STATE OF HAWAII
DEPARTMENT OF TRANSPORTATION
HIGHWAYS DIVISION

INTERSTATE ROUTE H-1
Kunia Interchange Improvements
F. A. I. Project No. 1M-HI-1(219)

ISLAND A SECTION
1/4"=1'0"

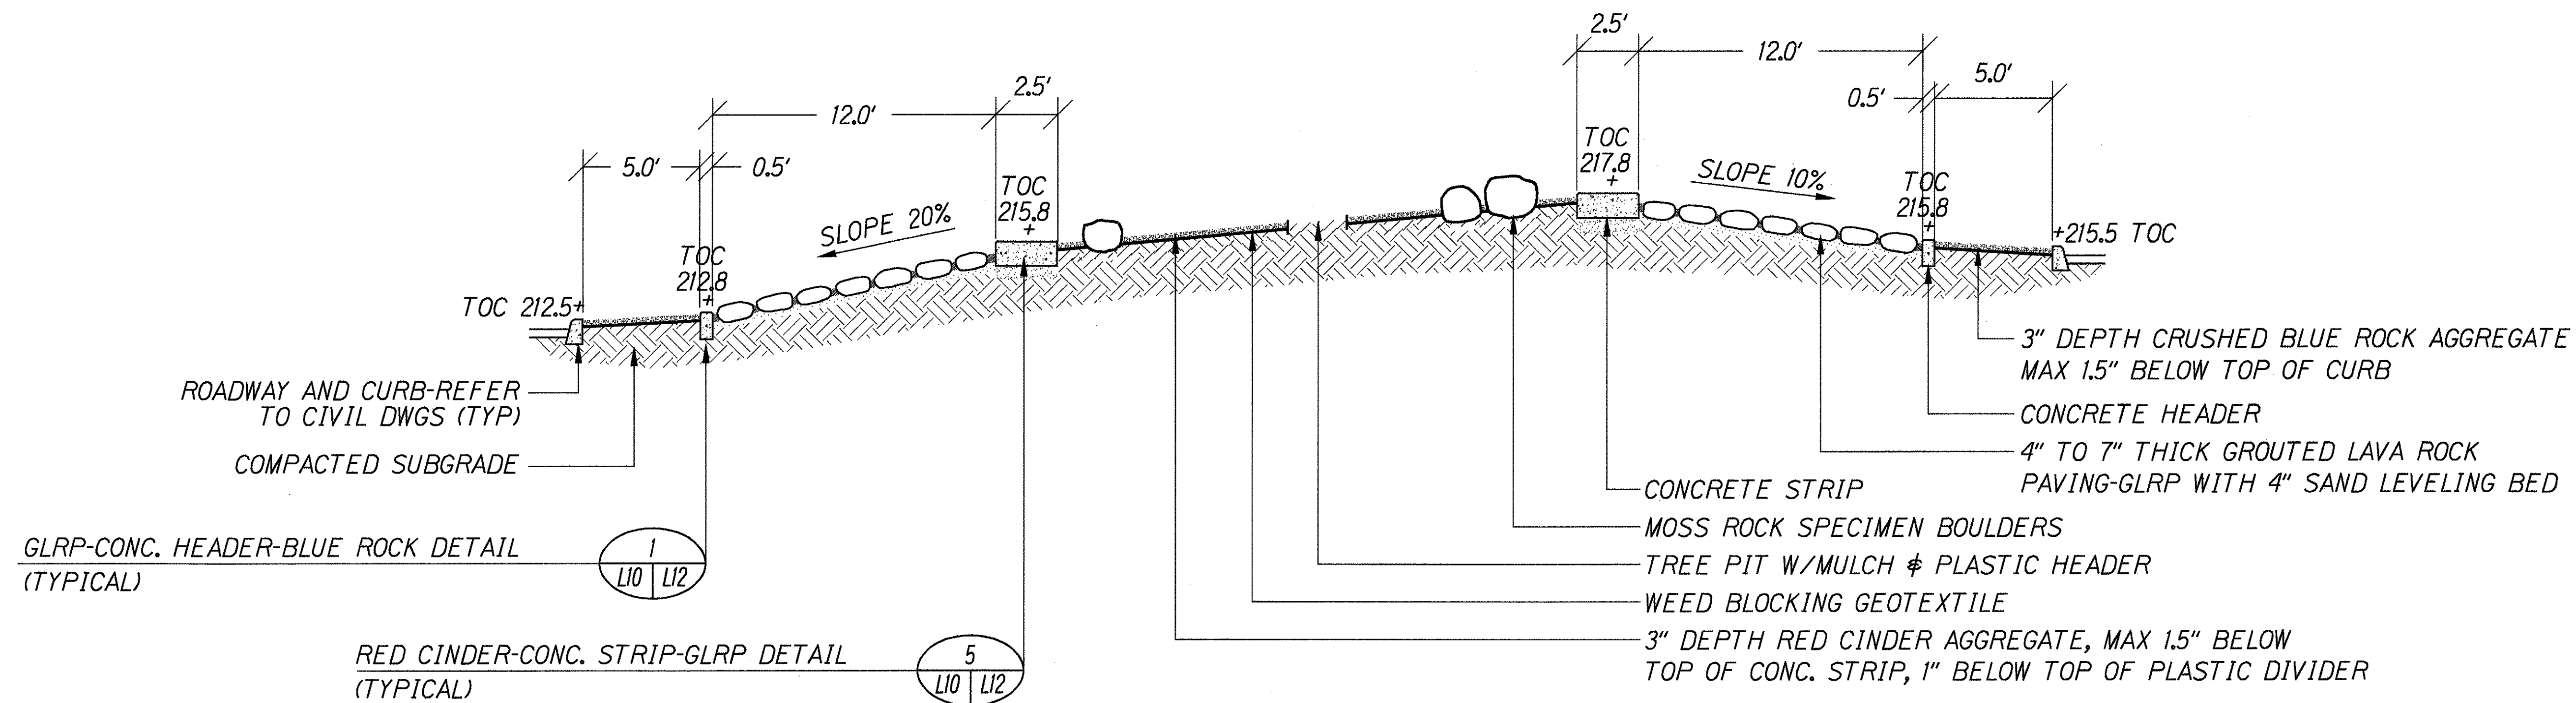
4/3/98	Revised Grouted Lava Rock Paving for Island A Section Per Addendum No. 2.
DATE	REVISION

SHEET No. 111 OF 52 SHEETS

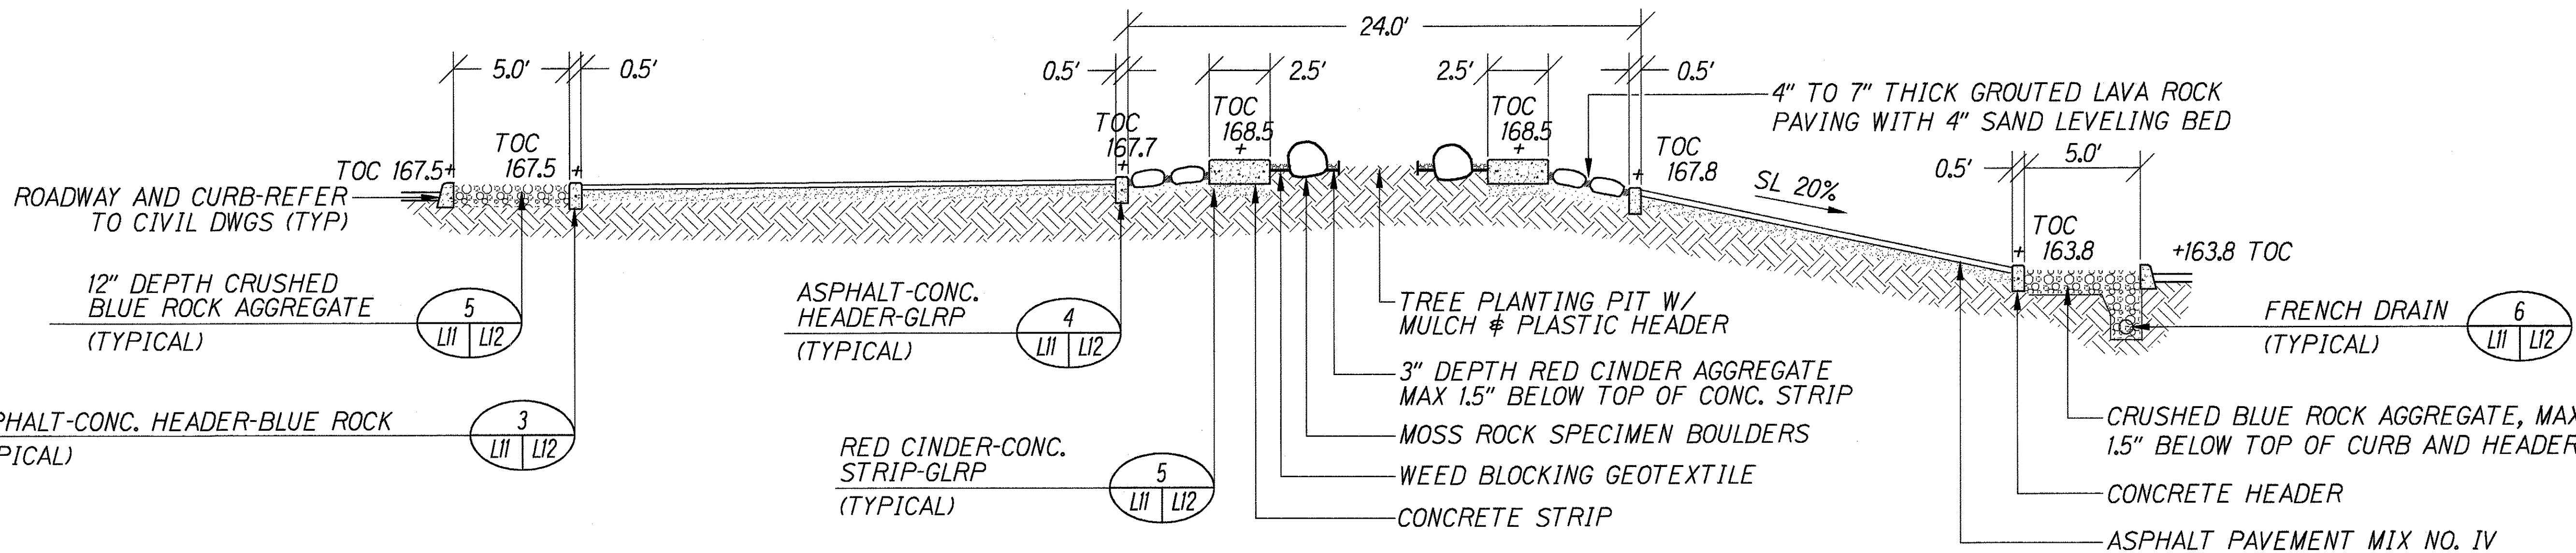
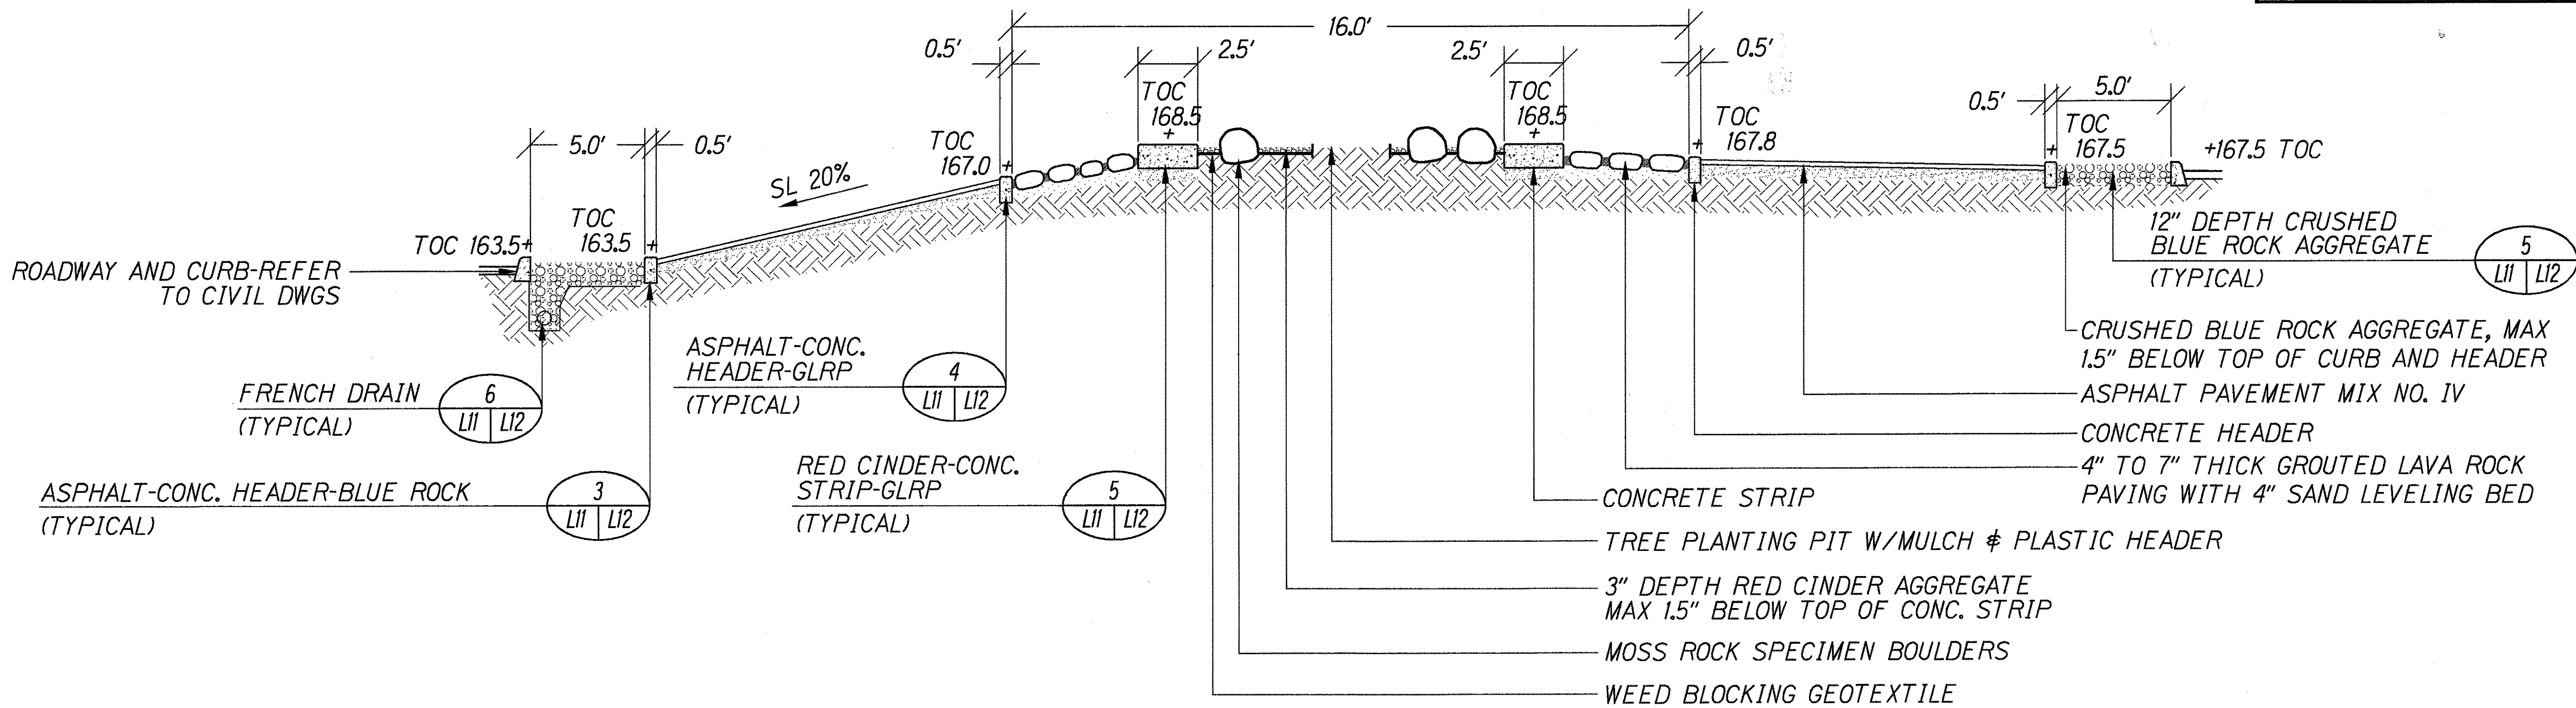
4/3/98	Revised Grouted Lava Rock Paving for Island C and Island E Sections Per Addendum No. 2.
DATE	REVISION

GATE VALVE ANCHOR BLOCK FOR PVC PIPE DETAIL

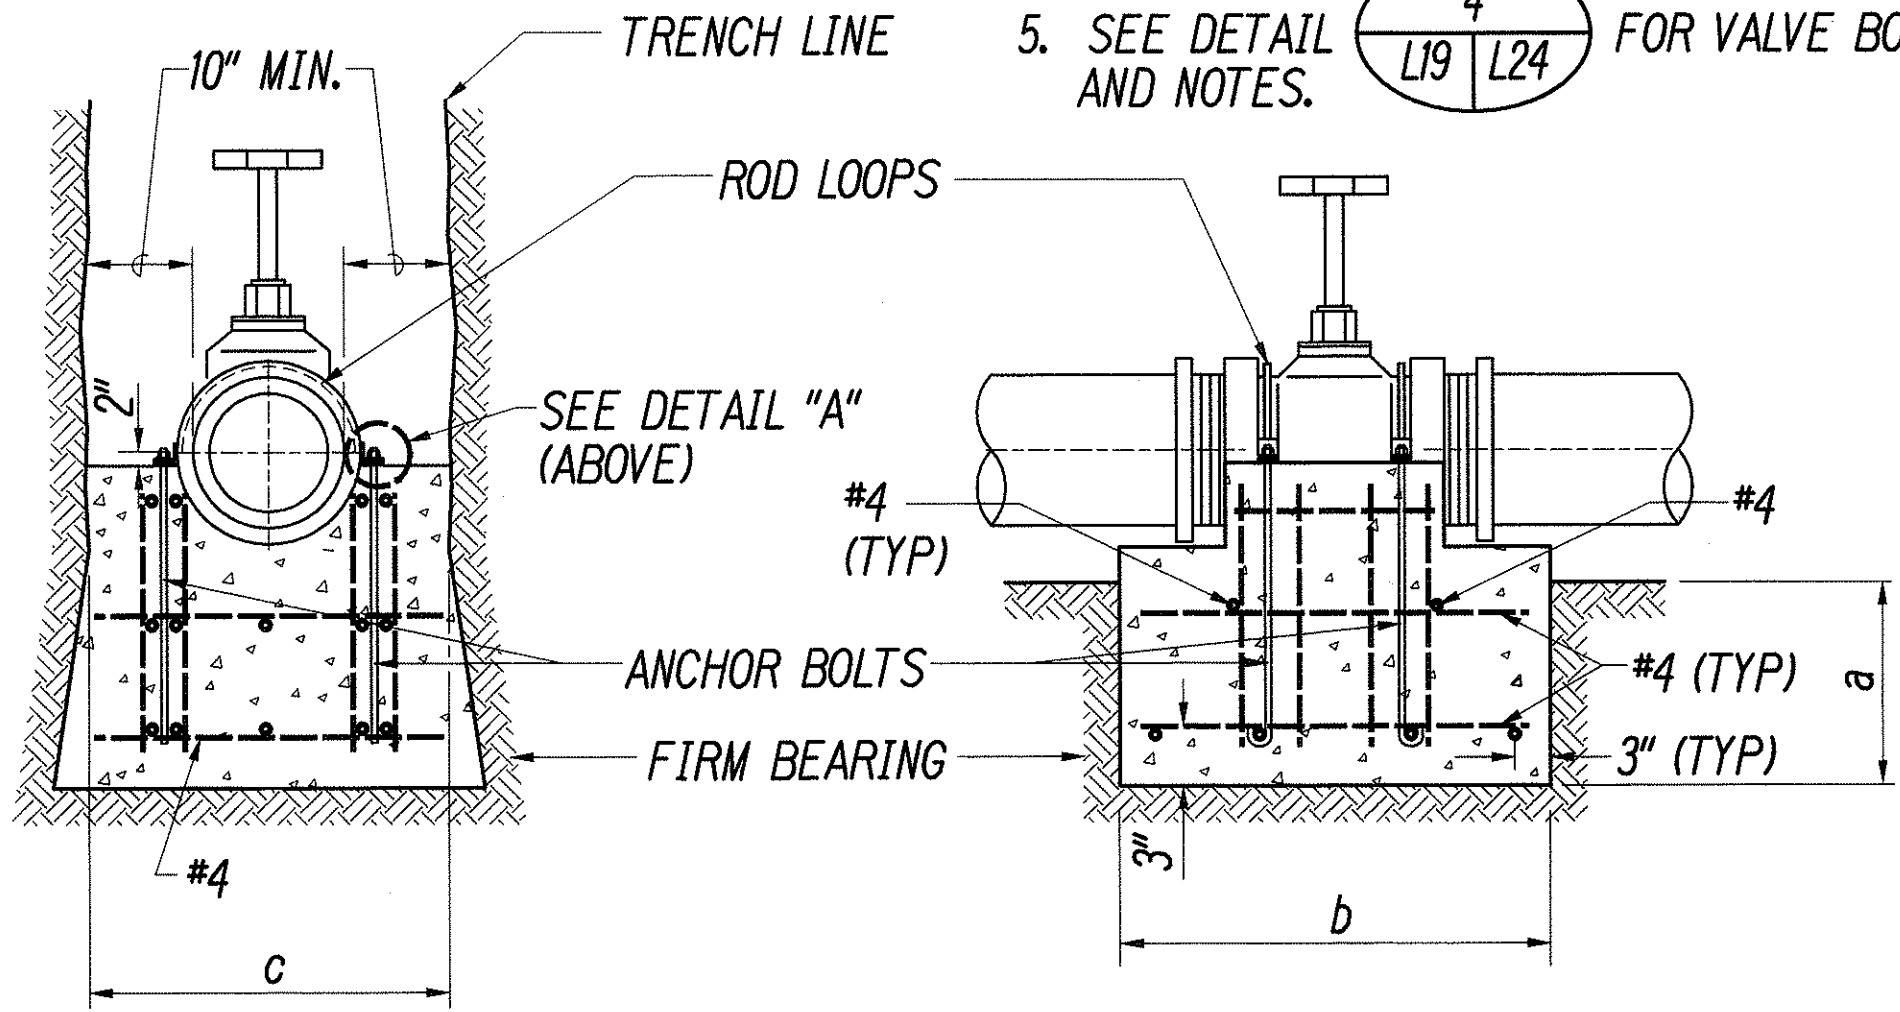
11/1/99	Added Gate Valve Anchor Block for PVC Pipe Detail.
4/3/98	Revised Description of Grouted Rubble Paving Per Addendum No. 2.
DATE	REVISION

SHEET No. L14 OF 52 SHEETS

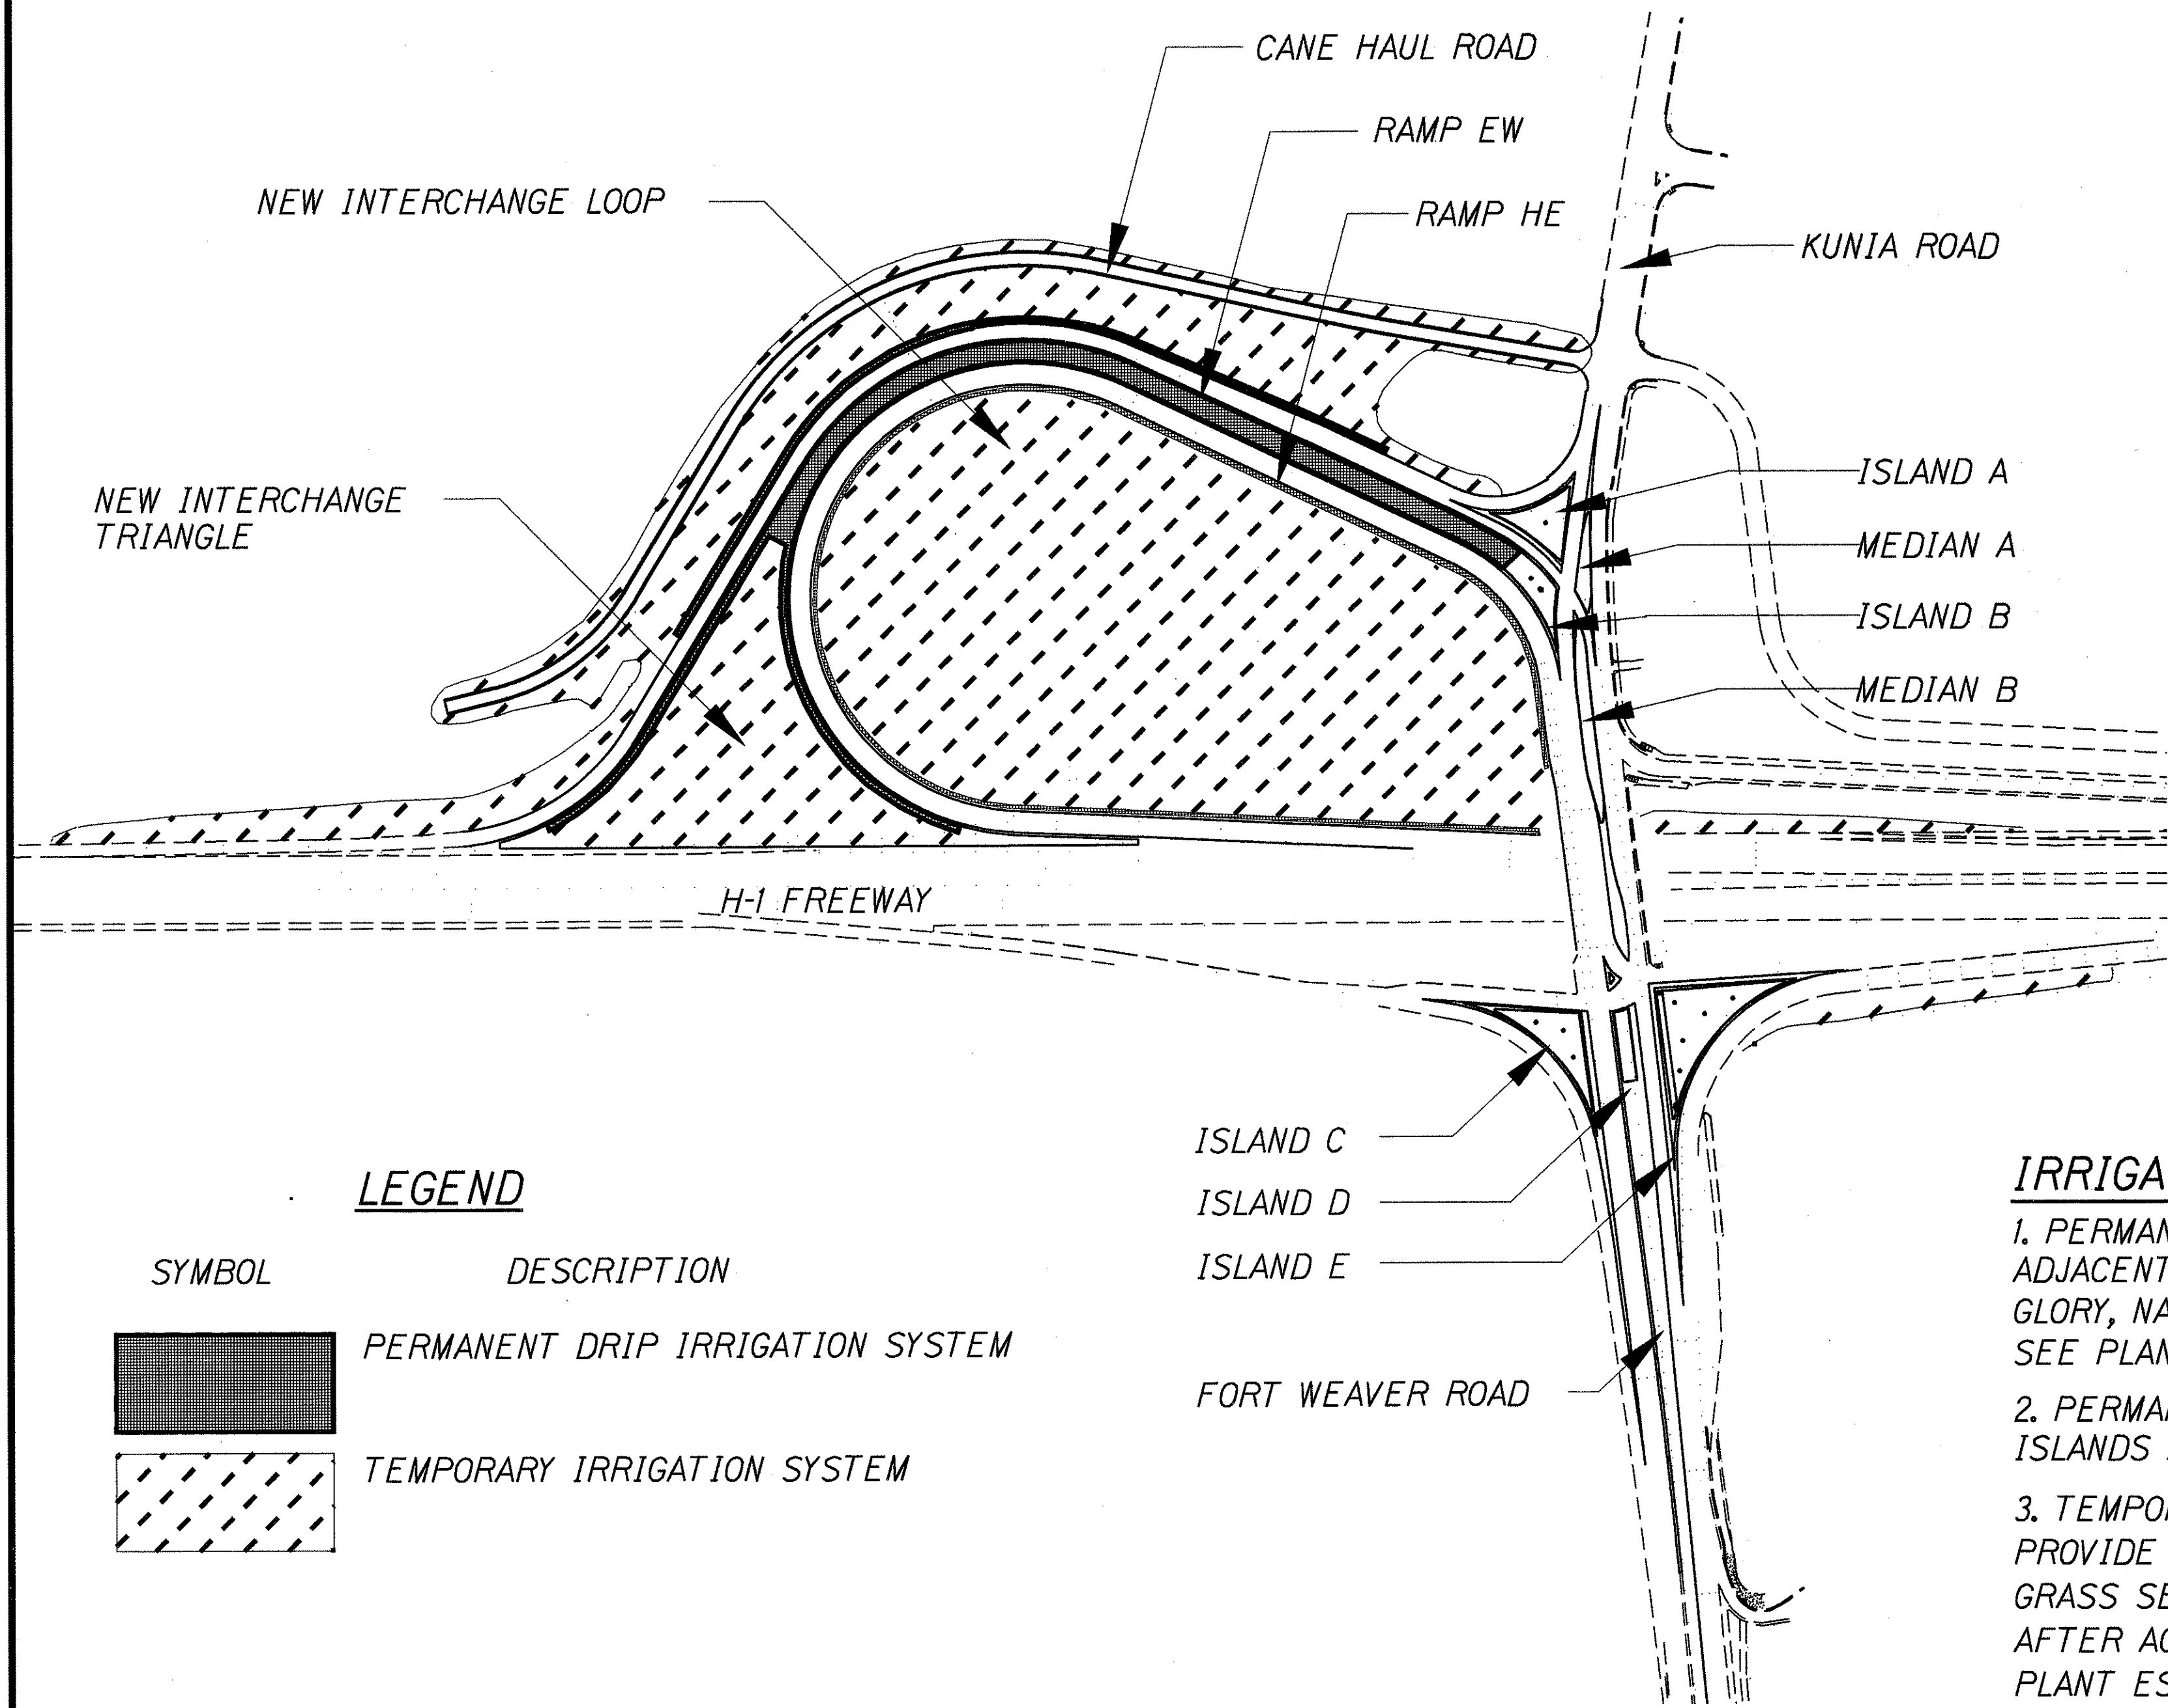
4/3/98	Revised Note Nos. 1 and 3 Per Addendum No. 3.
DATE	REVISION
